REPORT OF THE HEARING COMMITTEE

WELLINGTON CITY COUNCIL REPORT OF THE HEARING COMMITTEE

PROPOSED DISTRICT PLAN CHANGE 48: CENTRAL AREA REVIEW

Diagram of site-specific development concept for 187 Featherston Street. First setback occurs at ~35m, second setback at ~50m, and the max threshold set at 65m (all heights measured above ground level).

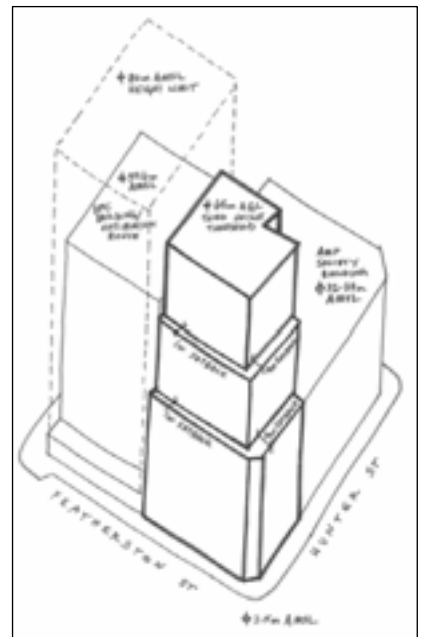
Submitter 16 (AMP NZ Property Commercial Ltd) originally submitted that their property at 187 Featherston Street (AMP Chambers) should be removed from the BNZ/Head Office Heritage Area, or alternatively that the permitted height for the site should be set at 80 metres. At the hearing the submitter presented a site specific development proposal for the AMP Chambers site, that the submitter considered was an appropriate response to the setting. The design (see image to right) extended up to a maximum possible height of 65 metres (above ground level) and made use of setbacks to ensure that the resulting building would respect the scale of the heritage area, provide a transition from the taller buildings to the north to the shorter heritage buildings to the south, and acknowledge the scale of the adjoining AMP Society building. The submitter provided the Hearing Committee with a three dimensional scale model of the proposed building in its setting, showing the surrounding buildings. The submitter requested that the Committee put in place a site specific rule to clarify that the development proposal was an appropriate development for the AMP Chambers site. Having visited the site, and considered the nature and scale of the surrounding buildings and spaces, the Hearing Committee agreed with the submitter that the proposed development scenario would be appropriate for the site. However the site visit also persuaded the Committee that there was potential for additional height on other sites within the BNZ/Head Office Heritage Area, given the area location in the heart of the 'high city' and the height of buildings on the perimeter of the heritage area. The height provisions for the area have therefore been amended to provide scope to consider scenarios such as that presented by AMP. Accordingly the Committee did not consider that a specific rule was required to codify the AMP proposal, and noted that the submitter may choose to investigate alternative options in the future. The Committee did however consider that it was worth including the development scenario in the design guide for the BNZ/Head Office Heritage Area, along with a note in rule 13.6.3.1.6 that in terms of building bulk it represented an appropriate design response for the site.

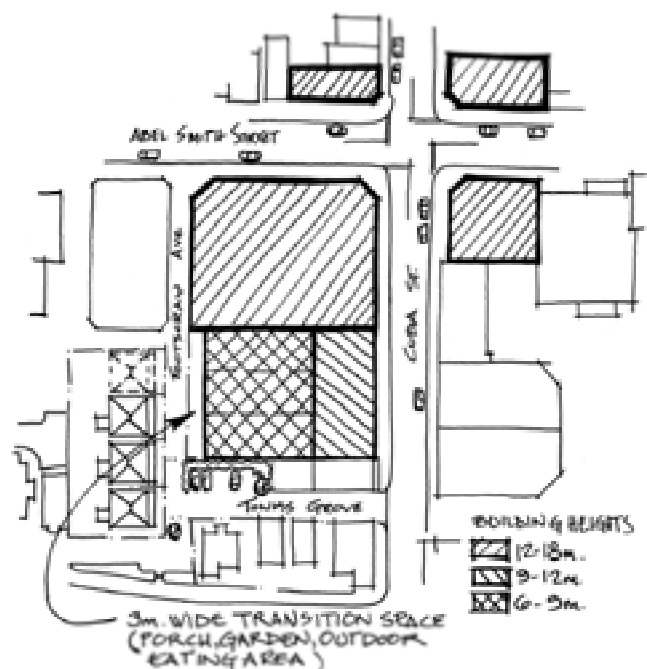
The Hearing Committee agreed with submitters that the sites between Abel Smith Street and Tonks Grove did have a different character to the properties south of Tonks Grove and west of Footscray Ave. The Committee installed a separate height regime for this portion of the heritage area to acknowledge this.

In terms of the heights that applied in this area the Hearing Committee identified a number of key issues that needed to be addressed. The Committee felt that additional height at the Cuba Street/Abel Smith Street intersection would help to anchor and enclose what is currently a fairly poor quality public space.

incorporated each of these issues. The scenario (see image to right) is not a specific design solution, but is intended to alert architects and applicants to the matters that need to be addressed in any future application.

Image: Footscray Avenue cottages

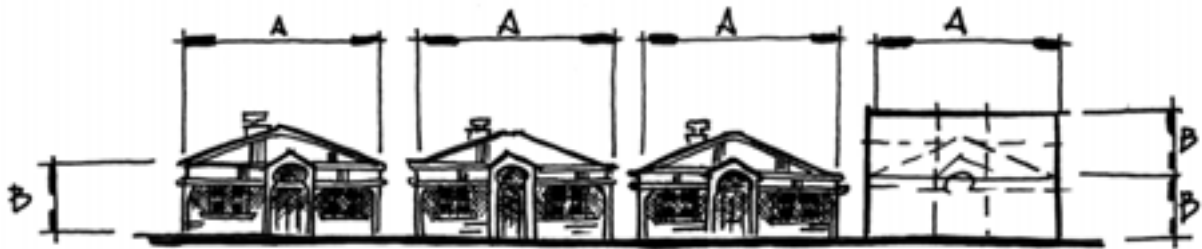
Submitter 26 (Dr Marko Klatkovic) owns the property at number 2 Footscray Ave (containing a cottage) as well as the larger commercial buildings to the north. The cottage is a listed heritage item that was damaged by fire in late 2006. The submitter opposed the inclusion of the cottage in the heritage area, and sought reinstatement of the previous 27 metre height limit. Having visited the site the Committee did not consider that the cottage should be removed from the Cuba Street Heritage Area (see section 3.78 for further details). The Committee considered that the Footscray Cottages were an important reminder of the city's past, and that the site at No. 2 Footscray Ave was important to the context of the remaining cottages, even if it was not possible to physically retain the fire damaged cottage. The Hearing Committee were strongly of the opinion that any future redevelopment of the site at No. 2 Footscray should echo the previous structure, and retain very strong links to the design and form of the remaining cottages (see image below).

The Committee directed that additional design guidance be included in the Cuba Street Heritage Area Design Guide to help clarify this matter.

Images provided by Studio Pacific Architecture – presented at hearing by AMP NZ Commercial Ltd

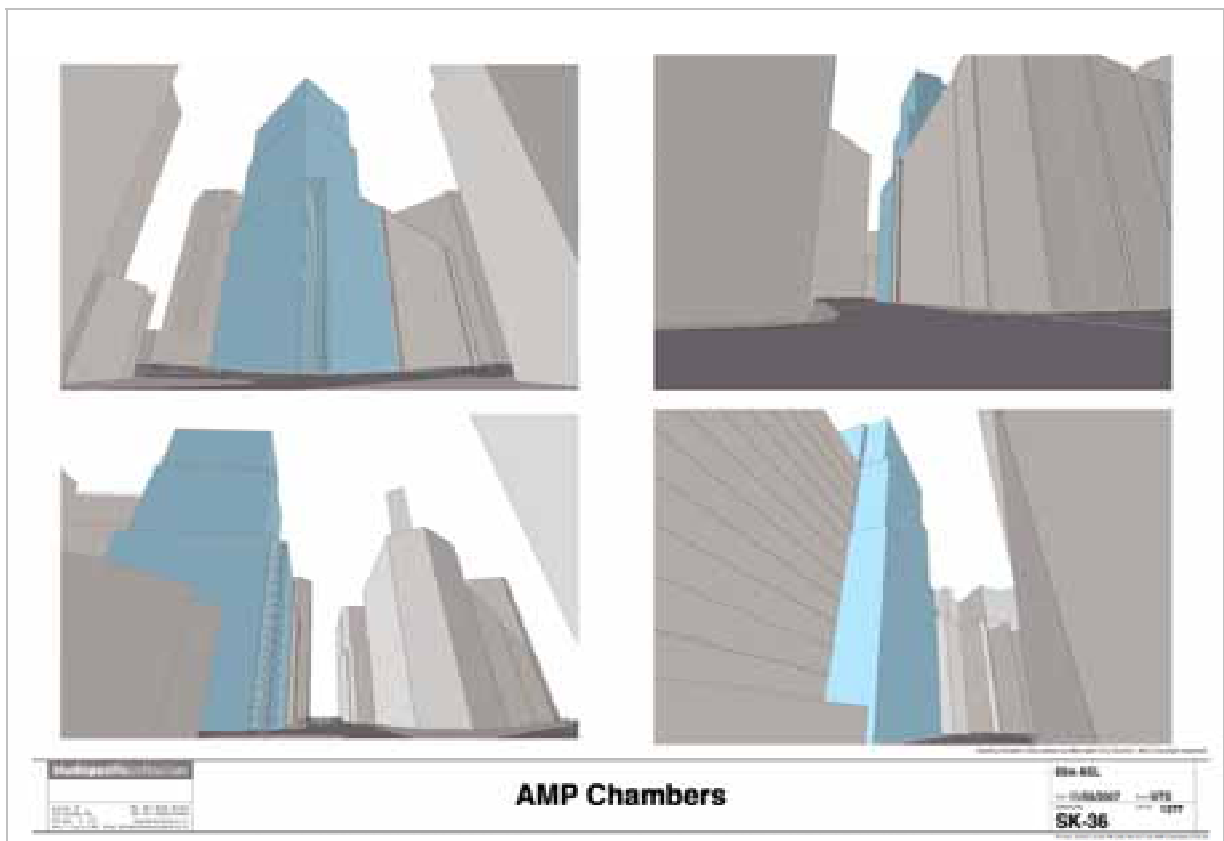
The Officer's report to the Hearing noted that the AMP Chambers building (187 Featherston Street) was an identified non-heritage building. The property had been included in the heritage areas because of its location in close proximity to some of the city's most significant heritage buildings (including the adjacent AMP Society building). The Officer's Report stated that if the site were to be redeveloped, retaining the property within the heritage areas would allow the relationship to the neighbouring buildings to be considered.

Submitter 16, AMP NZ Property Commercial Ltd (AMP), appeared at the hearing to discuss this matter in further detail. Rather than focusing on the removal of the AMP Chambers building from the heritage area, AMP tabled a site-specific proposal to address the further use and development of 187 Featherston Street. The submitter noted that the existing AMP Chambers building was already taller than the proposed maximum height of 25 metres. The submitter argued that with the use of appropriate setbacks, it would be possible to develop additional height up to 65 metres, without significantly impacting on the values of the heritage area, or the setting of the adjacent AMP Society building. The submitter provided models of the proposed heights to indicate how the additional height could be integrated into the local streetscape. The submitter considered that the key elements of their site-specific proposal should be incorporated into the District Plan, with provision for the final building detail to be considered as a Discretionary Activity (Restricted).

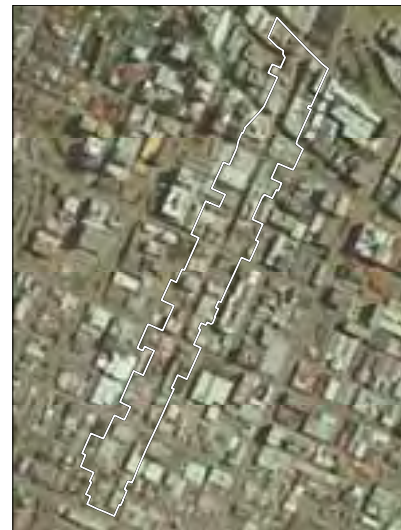
- The submitter opposes the proposed height restriction change, in particular Cuba Street south of Abel Smith St (Heritage area 13.6.3.1.6). The submitters preferred option is that the currently height restriction remain in place. A second option would be that upper Cuba Street (south of Abel Smith St) should have all the same height restrictions. A third option

would be to include 250-264 Cuba Street in the area between Dixon and Able Smith Streets (maximum height of 18 metres) (submission 8).

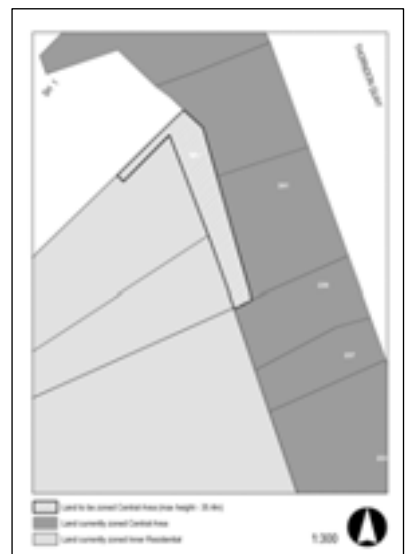
- The submitter opposes the zoning of the former Hotel Cecil site which excludes the part area of bus parking that is under dispute with the Wellington City Council (with that part being left as 'road'). The relief sought is the incorporation of the whole of the former Hotel Cecil site within the Central Area zone. As an alternative relief, the provision of adequate financial compensation for the "taking" of the land for road purposes, with the financial compensation being based on an underlying zoning of Central Area (submission 53).
